TORREY PINES TECHNOLOGY
P.O. Box 81608
San Diego, California 92138
Telephone: (714) 455-2654

March 24, 1982

POTENTIAL FINDING REPORT SONGS 2&3 SEISMIC DESIGN VERIFICATION

Front Loading
Top-to-Bottom

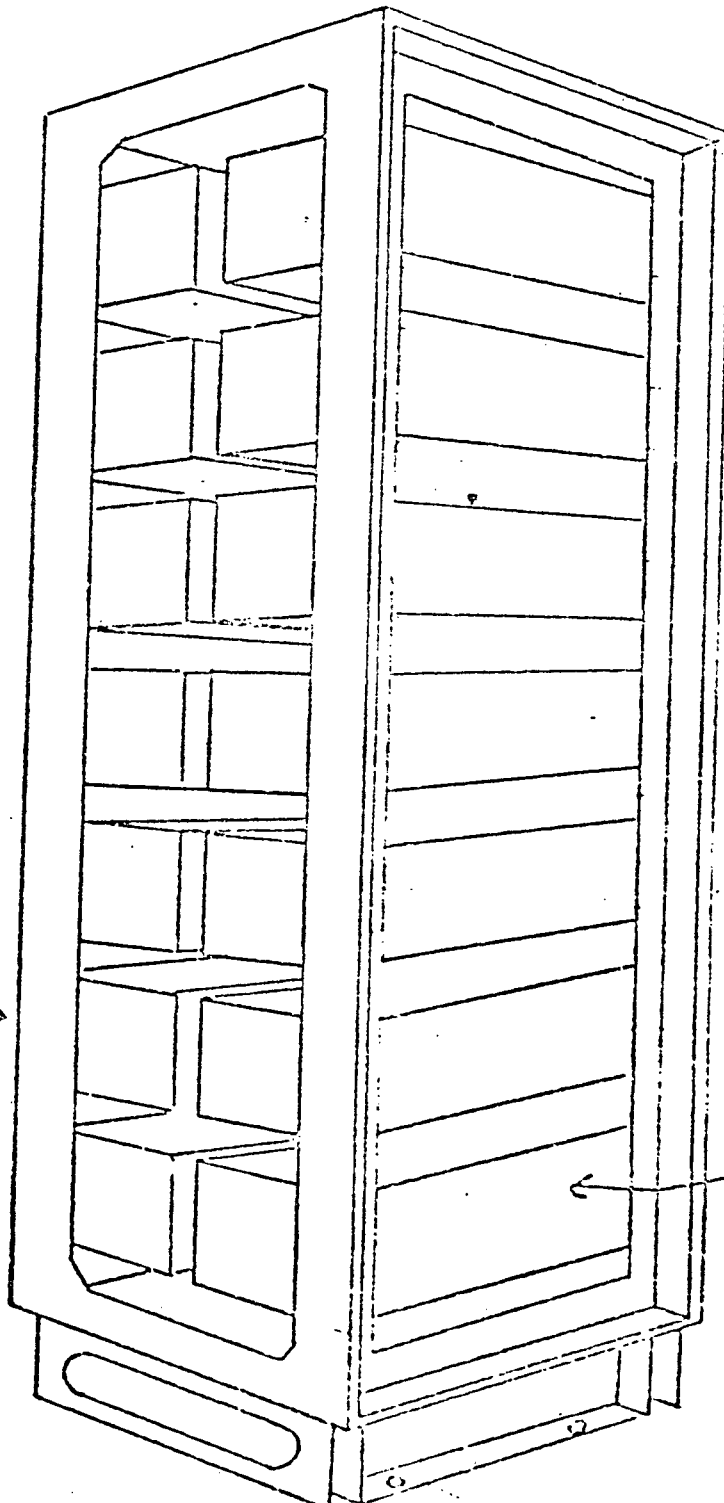
- a. The dummy loaded rack was vibrated at a constant acceleration of 0.5g at 1 octave/min from 1 to 35 Hz in three mutually perpendicular axes. The rack and its load were monitored with triaxial accelerometers located as in Diagram No. 4. Two load configurations were tested in each plane. See Diagram No. 1 for a drawing of both loads.

The results indicate that with minor modifications the rack will be suitable for seismic environments of up to 2.0g's for the loading configurations tested.

DESIGN BASIS EARTHQUAKE
VERTICAL ACCELERATION RESPONSE
SPECTRA AT NODE 5, ELEVATION 30' 0"
OF CENTRAL CONTROL AREA, AUX. BLDG.

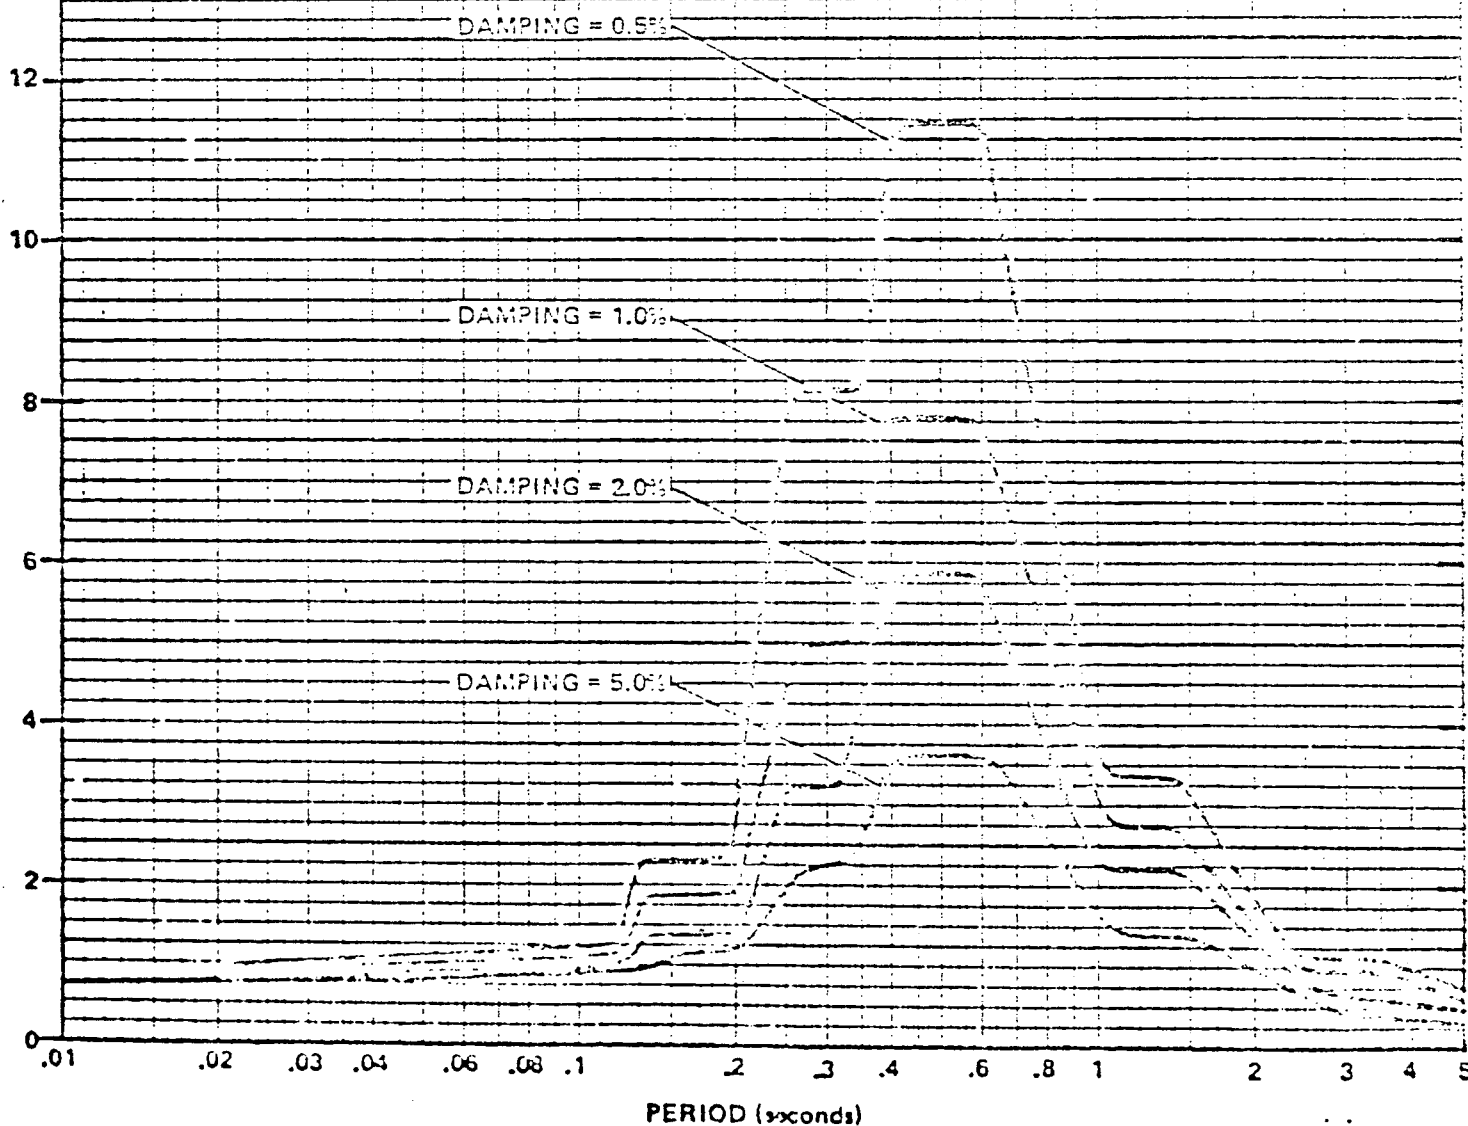
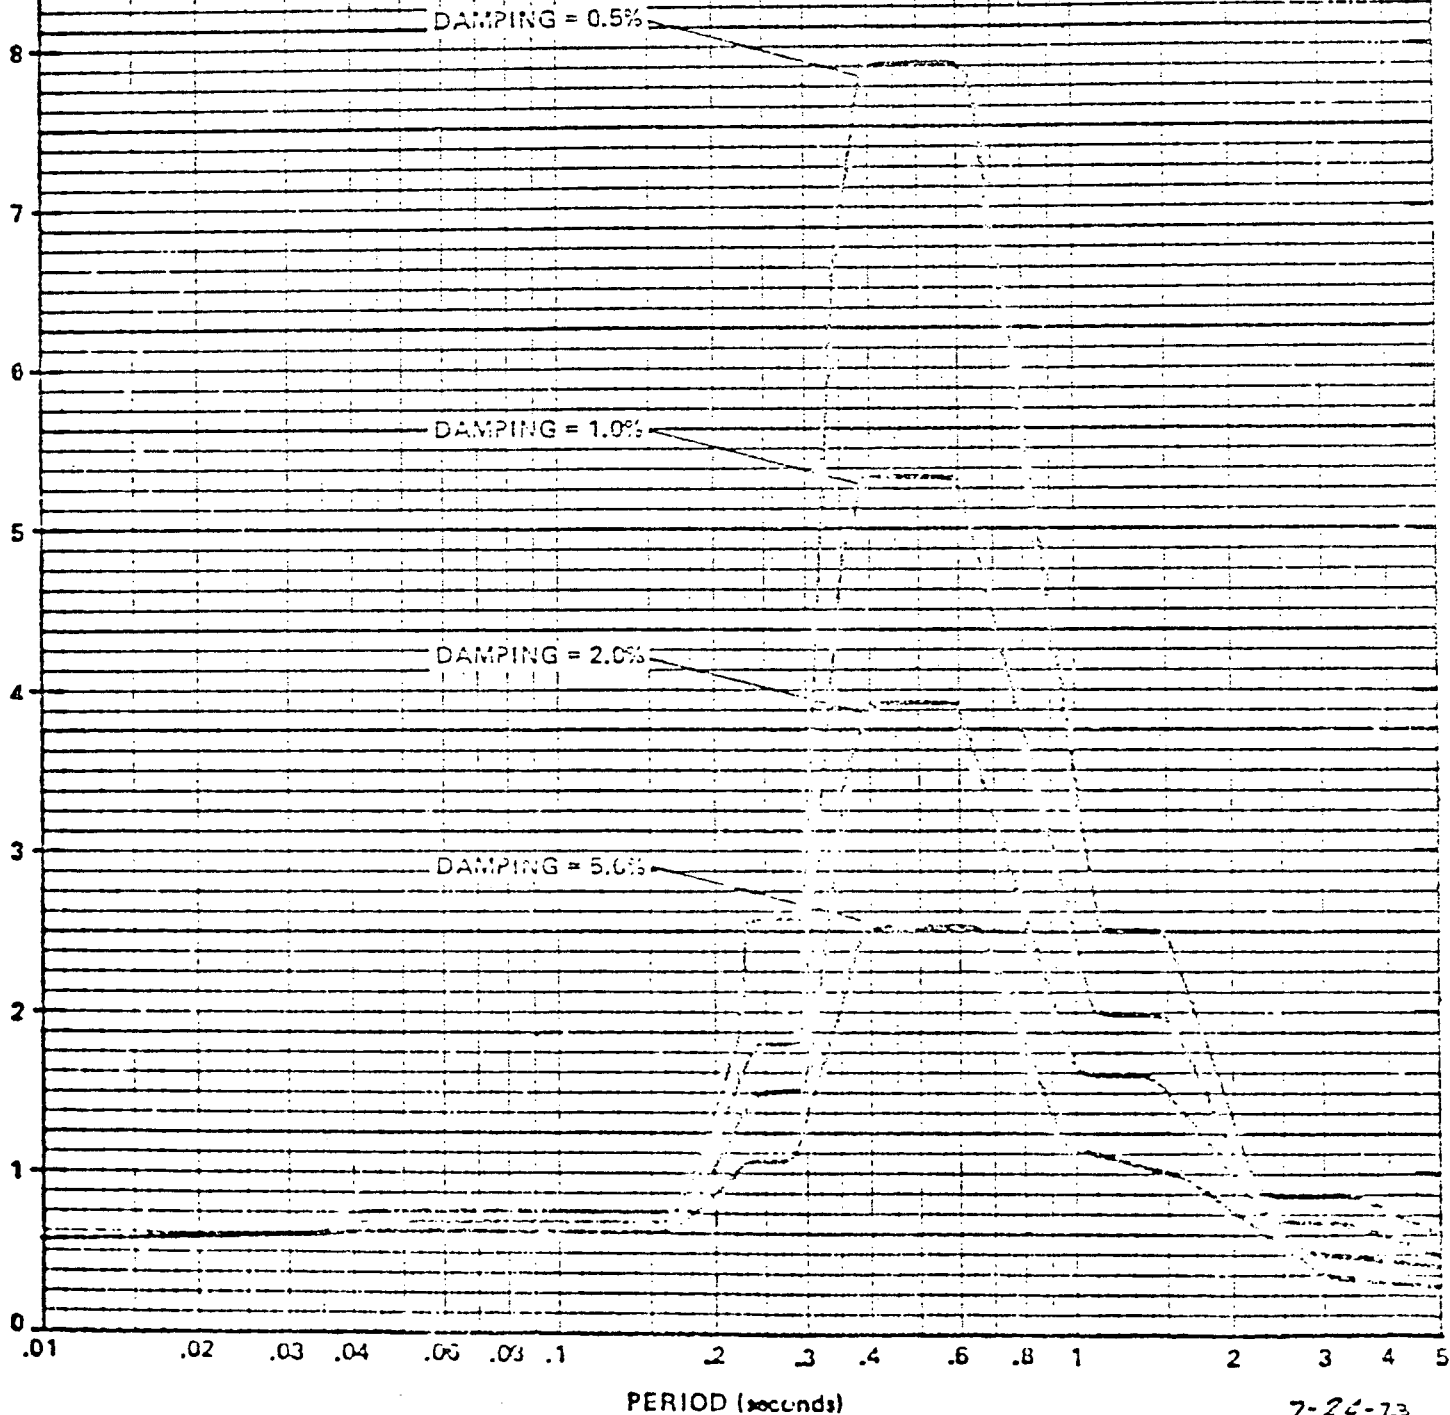
CE received a set of response spectra for the Auxiliary Building 7/24/73 (transmittal letter No. Log BC-2/3, SCE to CE). The specific curves for the 30' level of the control area of the Auxiliary Building are S0230-SK-S-695, 696, 719 and 720 Revision A (i.e., Node 5).

Since all of predominant resonances are above 10 Hz, examination of the specific response spectra (S023-SK-S 695 and 696, Rev. A) show the curves for 5% damping are down essentially to the ZPA (i.e., approximately 1g). Thus, the panels have been qualified to operate in this specific location.

I believe these panels are reasonably conservatively designed for their specific location in the Auxiliary Bldg. Also CE summary document CEN-94S (Data Sheet 6), that these panels are qualified to 1g is correct.

A cross section of the nozzle is:

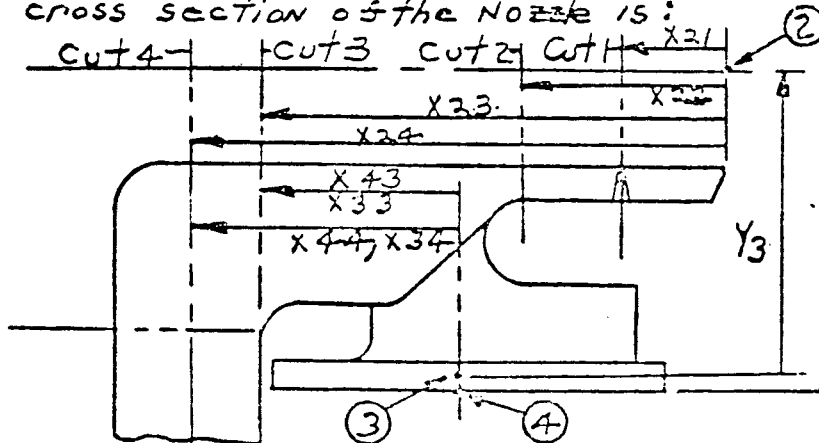
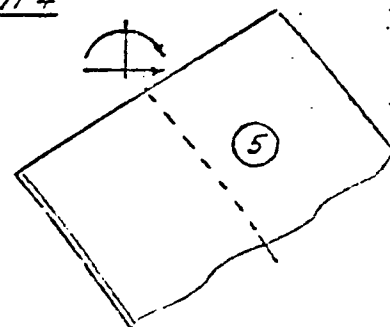
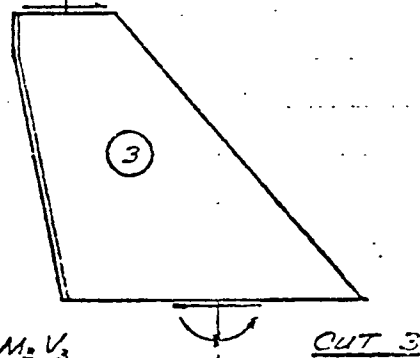
The CE response explains that the assumption made to simulate the cylindrical Reactor vessel by a spherical shell vessel with $1.5 R^*$ in the calculation of nozzle/vessel stresses is more sensitive to the evaluation of low cycle fatigue damage than the calculation of primary membrane stresses resulting from the loading combination of design pressure and the OBE and DBE for upset and faulted conditions. It is recommended, with the agreement of the initiator, that the PFR-F0109 should be reclassified as an invalid ^{potential} finding.

Reply: The inlet nozzle is located in a cylindrical shell of radius R . However, an interaction model of the nozzle to shell juncture, which was used in conjunction with the stress analysis, utilizes an axisymmetric simplification which consists of replacing the cylindrical vessel shell with a spherical shell of radius $1.5R$. This simplification permits the average pressure stress to be maintained and provides a mathematically acceptable model for analysis. CE recognizes that such an assumption produces approximate solutions and accordingly utilizes the results of such an analysis to a limited extent.

DESIGN BASIS EARTHQUAKE
 HORIZONTAL ACCELERATION RESPONSE
 SPECTRA AT NODE 5, ELEVATION 30'-0"
 OF AUXILIARY BUILDING

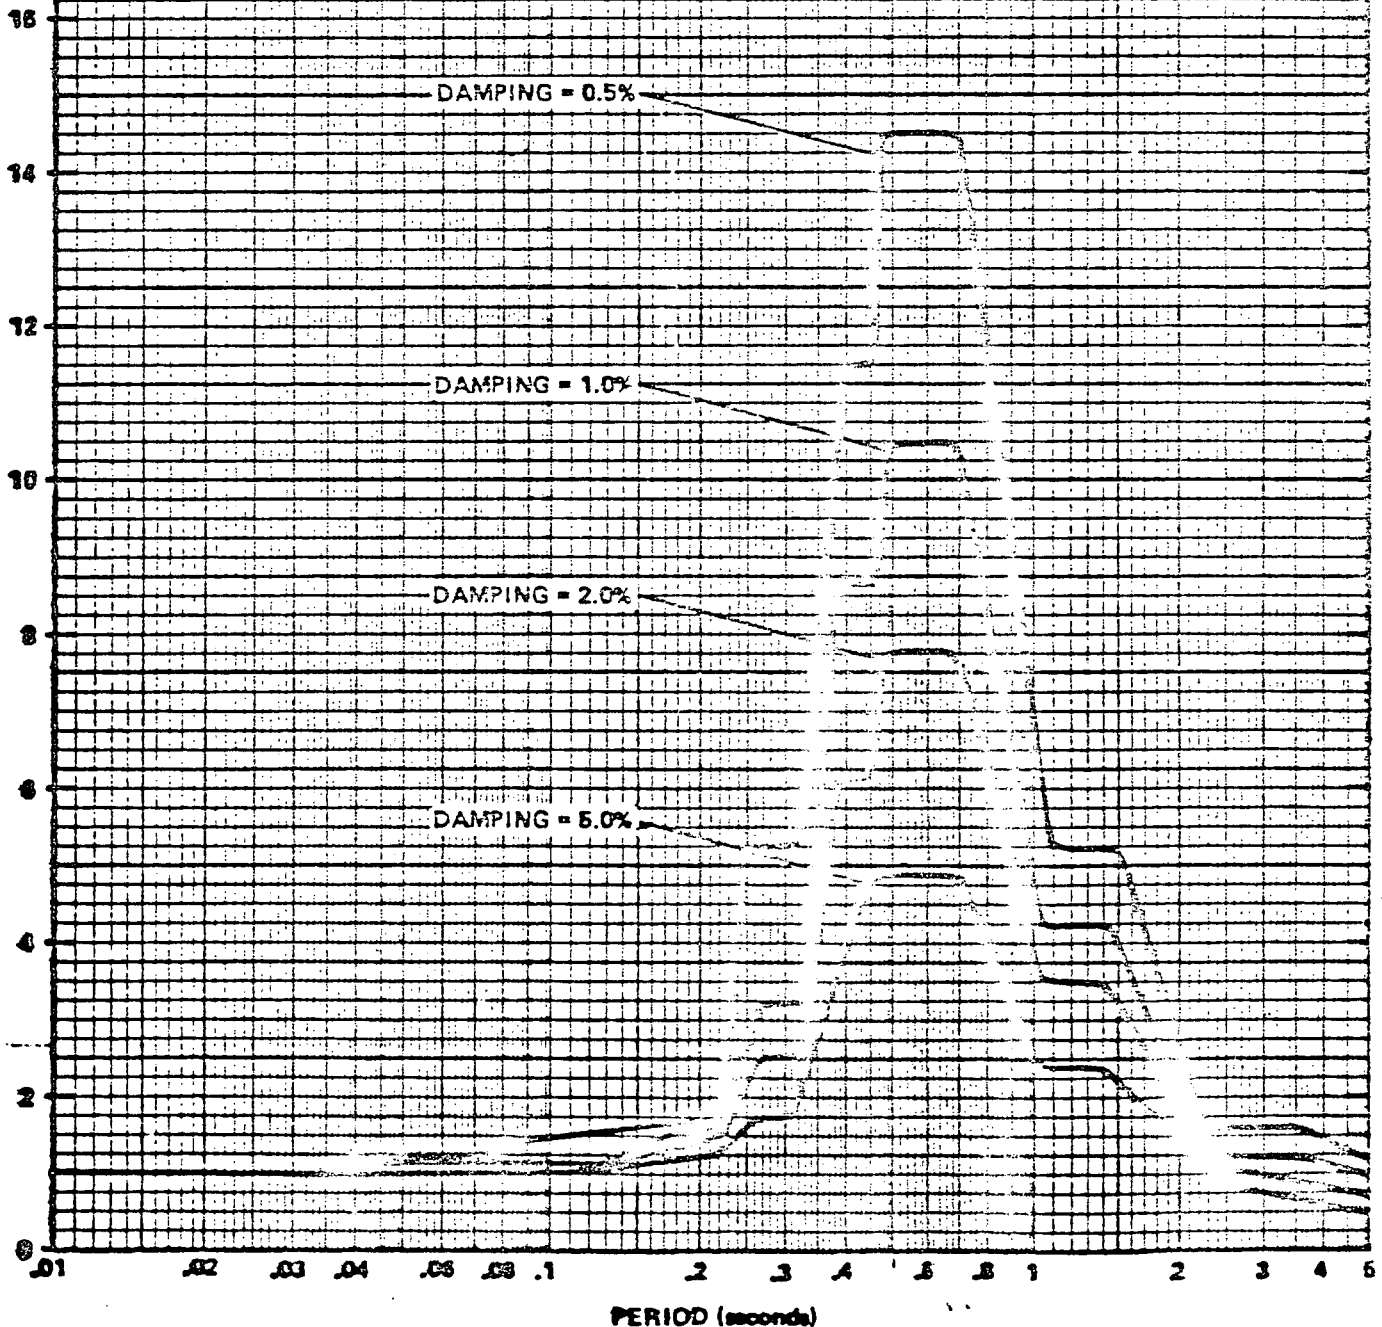
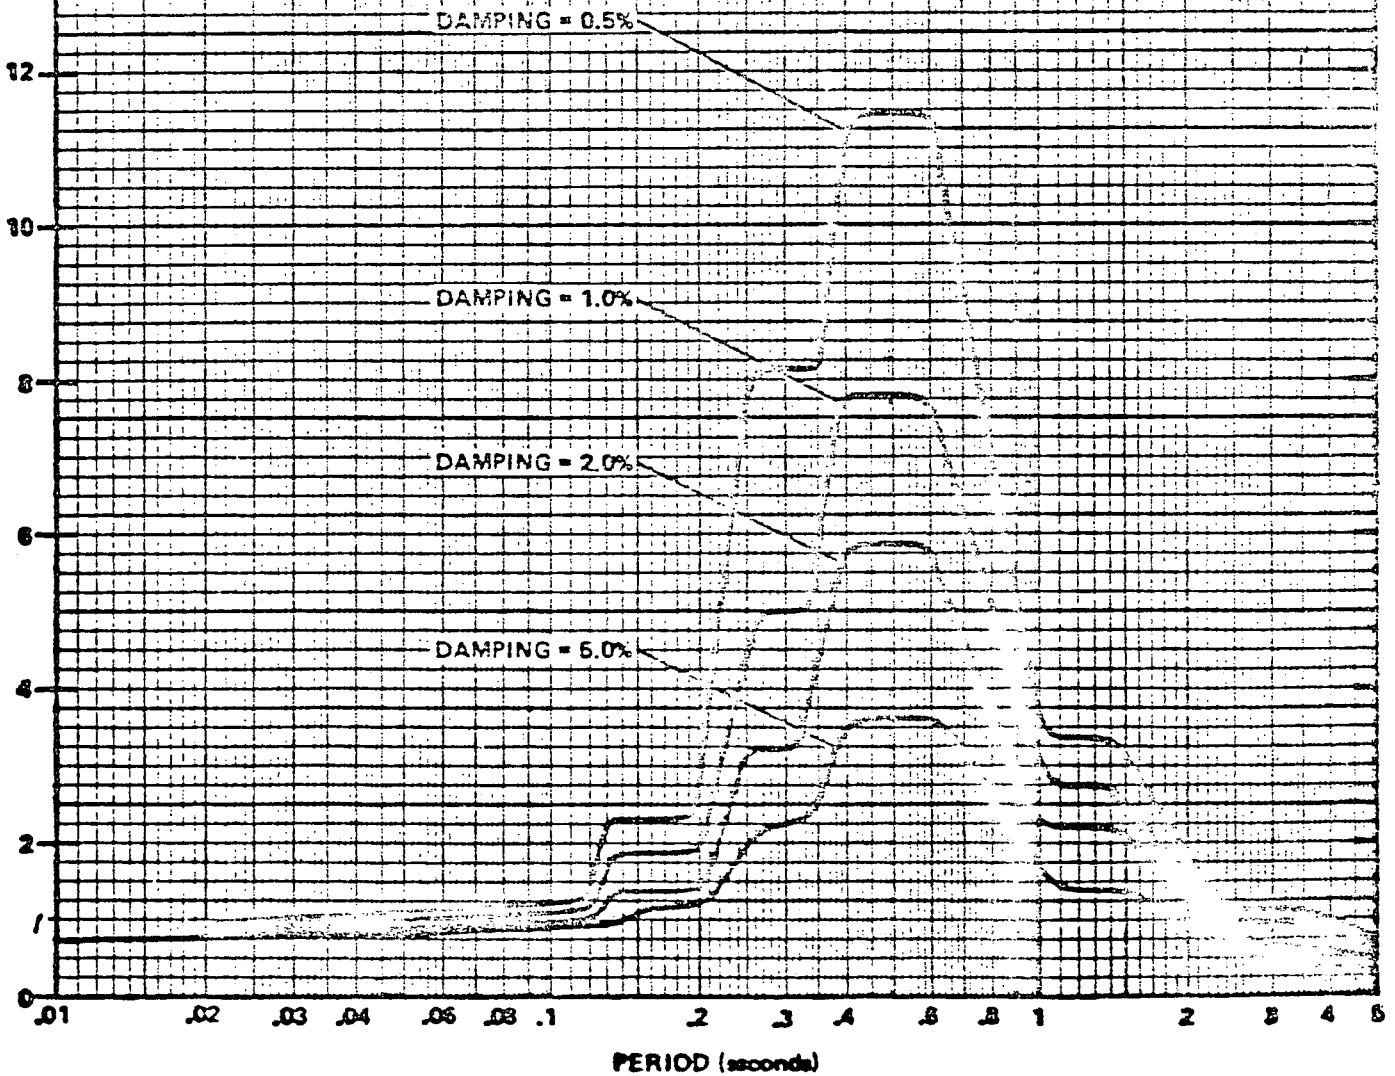
This indicates that the input motion to the control cabinets does not contain driving frequencies higher than about 10 cps (see attached sketches no. S023-SK-S-695 and 696). The discrete frequency content (.5 to 7.5 cps) of the floor acceleration response is derived from the "filtering effect" of the building response dominated by soil/structure interaction, and results in motion with no driving energy at the high frequency range, i.e., $f \geq 10$ cps.

FIGURE 1

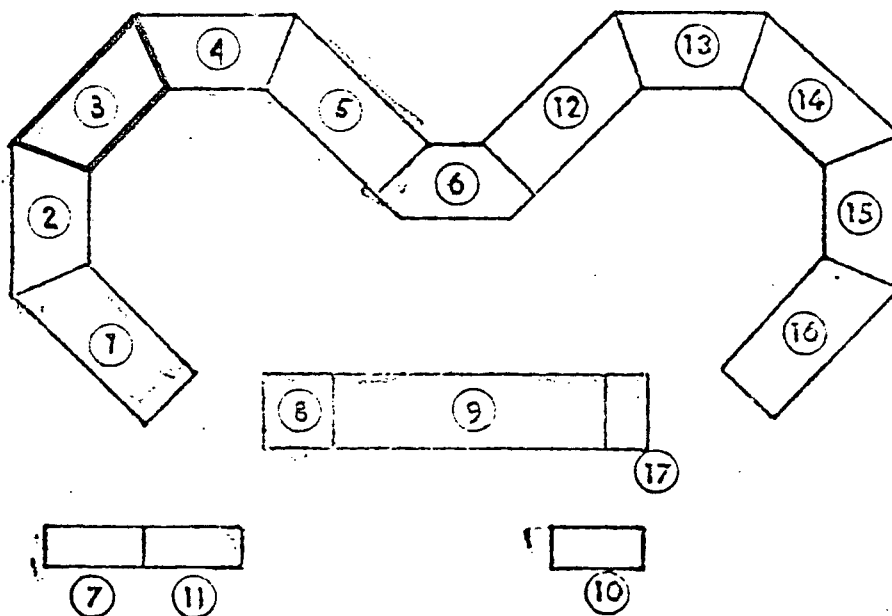
The configurations tested were portions of the total assembly, specifically shipping unit 3 of the double horseshoe arrangement shown in Figure 1. Shipping unit 3 with dummy weights attached to simulate internal equipment and gauges was attached to a dynamic shaker table in the same manner as the actual installation in the Reactor Auxiliary Building. The first structural mode (front to back vibration) natural frequency was found to be 10 Hz. Two subsystems (Panels) modes were identified at 7.8 and 22.5 Hz. The maximum acceleration in the cabinet was found to be 2.2g's.

GELCO maintained that an in-situ test would need to be performed to find out. The in-situ test showed that cabinet 3 had a 33 Hz first fundamental frequency in the forward and backward mode and the cabinet 1 (Figure 1) had a corresponding frequency of 28 Hz. This raised the question by the reviewer as to whether the 22.5 Hz panel could be amplified beyond what the response spectra indicated by coupling with the 28 Hz structural mode assuming the same panel existed in shipping unit No. 1. Initial estimates indicated that the 3g limit could be exceeded if the mass ratio of the submass to the structural mass was low enough (about .01). Estimated values ranged from ~ .055 to ~ .02.

The PFR as written against the design specification is valid in TPT's opinion.
